Historic Resources Board

Staff Report

Agenda Date: June 5, 2013

Subject: 505 Embarcadero Rd [12PLN-00206]: Request by Heather Trossman, on behalf of Nicholas Jitkoff and Ty Ashford, for Historic Resources Board review and recommendation regarding proposed restoration, alteration and addition to a residence listed on the City's Historic Inventory in Category 4 and located in the Professorville Historic District. The project includes Individual Review for a second story addition of more than 150 square feet, an HIE for a small two-story encroachment in the rear yard, and a fence variance. Environmental Assessment: Exempt from the California Environmental Quality Act per Section 15303. Zone District: R-1.

Figure A: Roof Deck revised design SF comparison

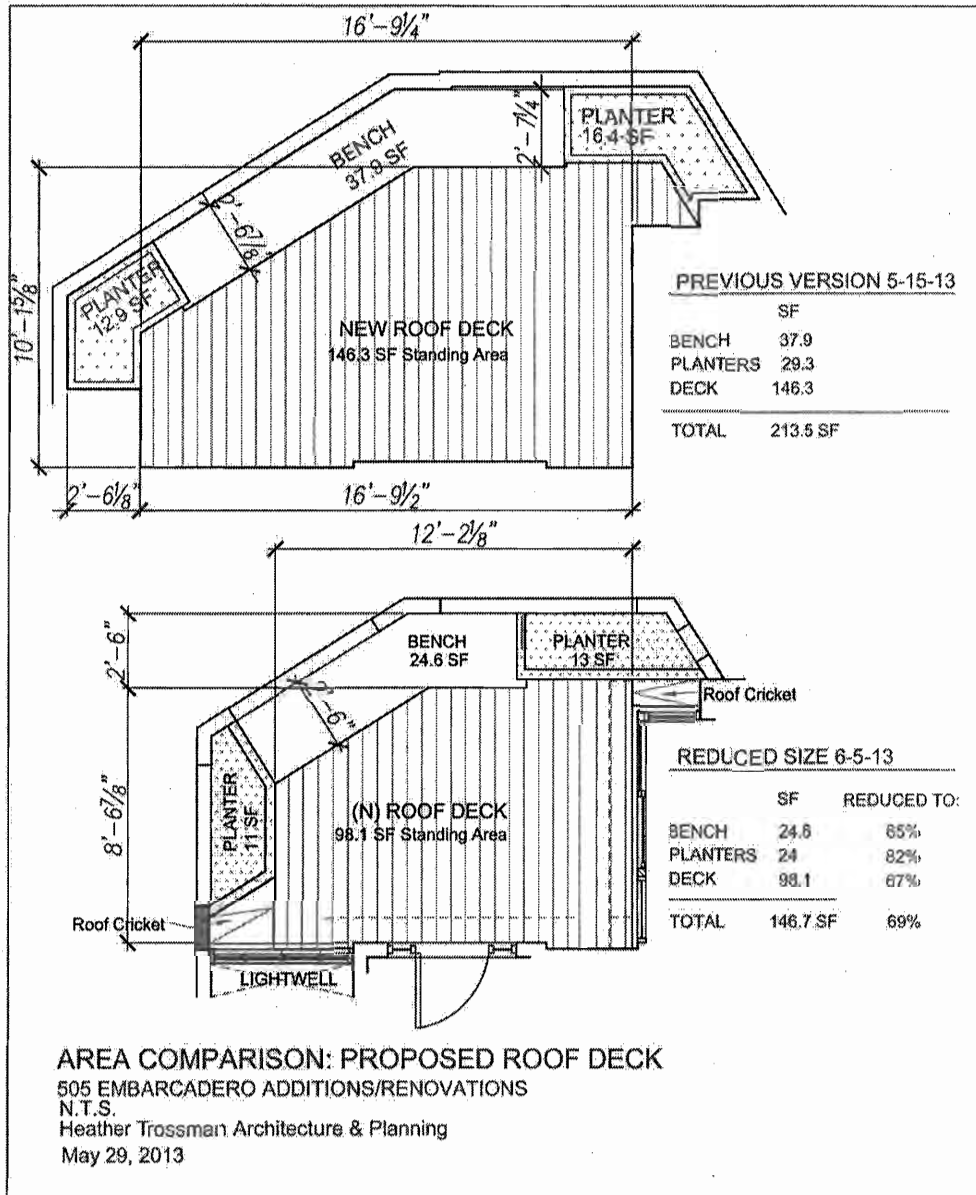
1. Dennis Backlund has suggested in the recent staff report that we consider sheathing the new portions of the house in shingles to match existing rather than with board & batten, in order to create unity of design and reduce apparent height of the addition; new windows and slight differences in eave detailing between new and old will be sufficient for differentiation. We have tried this and agree that it is the best sheathing option. New shingles will be detailed and stained to match existing. See revised sheet A-4.
2. Planning staff have asked us to reduce the size of the 2nd floor roof deck. We have reduced it as follows, and include a diagram at the end of this addendum, Figure A:

Date	Bench SF	Planters SF	Deck SF	Total SF
5-15-13	37.9	29.3	146.3	213.5
6-05-13	24.6	24	98.1	146.7
Reduction to:	65%	82%	67%	69%

This includes changing a portion of the bench into a longer planter, to further isolate the bench from the neighbors at 1416 Tasso. We have reduced the deck area by
